Access Compliance Report

Public Rights-of-Way

Intersection ID: 3761	Main Street: KEENELAND_LN	Cross Street: CLAIBORNE_WOODS_RD	Location: NW
ADA ID: ED7D43468586	Ramp Type: Perp	Initial Pass/Fail: Fail	Overall Compliance: No
Severity Score: 8.75			
Codes/Mitigation Info/Possible Solution		Field Measurements/Component Compliance

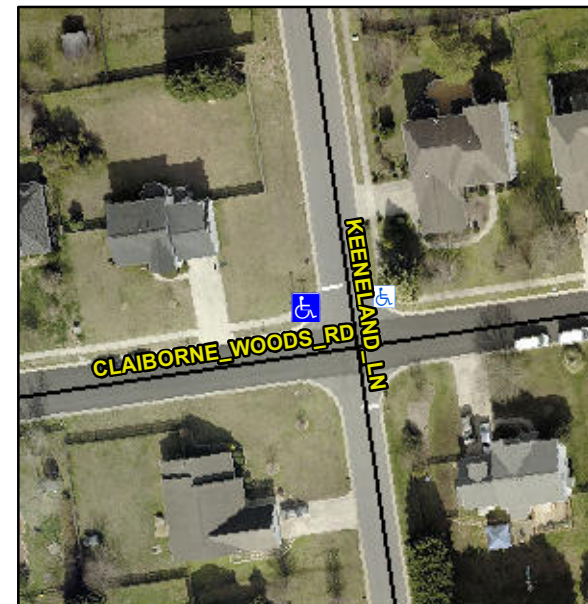
Not Found, R304.5.1

Compliance	Description	Data	Compliance	Description	Data
N/A	Ramp Length (in)	48.0	Yes	Ramp Slope (%)	7.9
No	Ramp Width (in)	42.0	Yes	Ramp XSlope (%)	0.4
N/A	Flare Type LT	N/A	N/A	Flare Type RT	N/A
N/A	Flare Slope LT (%)	N/A	N/A	Flare Slope RT (%)	N/A
N/A	Flare Traversable LT?	N/A	N/A	Flare Traversable RT?	N/A
N/A	Landing Length (in)	N/A	N/A	DWS Provided?	N/A
N/A	Landing Width (in)	N/A	N/A	DWS Contrast?	N/A
N/A	Landing Slope (%)	N/A	N/A	DWS Length (in)	N/A
N/A	Landing X Slope (%)	N/A	N/A	DWS Full Width?	N/A
N/A	Landing Curb? (Y/N)	N/A	N/A	DWS Offset (in)	N/A
N/A	Shared Landing?	N/A			
N/A	Gutter Ponding?	N/A	N/A	Gutter Slope (%)	N/A
N/A	Gutter Lip Ht (in)	N/A	N/A	Gutter X Slope (%)	N/A
N/A	Painted X Walk1?	No	N/A	Painted X Walk2?	N/A
	X Walk 1 Direction	To E		X Walk 2 Direction	N/A
N/A	X Walk 1 Width (in)	N/A	N/A	X Walk 2 Width (in)	N/A
	X Walk 1 Slope (%)	0.1		X Walk 2 Slope (%)	N/A
	X Walk 1 X Slope (%)	0.7		X Walk 2 X Slope (%)	N/A

N/A	Ramp inside XWalk1?	N/A	N/A	Ramp inside XWalk2?	N/A
	Road Slope (%)	N/A	N/A	Clear Space?	N/A
	Road X Slope (%)	N/A	N/A	Clear Space to XWalk (in)	N/A
N/A	Any Obstructions?	N/A	N/A	Storm Grate/Utility Hazard?	N/A
	Obstruction Type			Storm Grate/Utility Type	
		N/A			N/A
			Yes	Surface Condition? (G/P)	Good

Remove & Replace Entire Ramp.
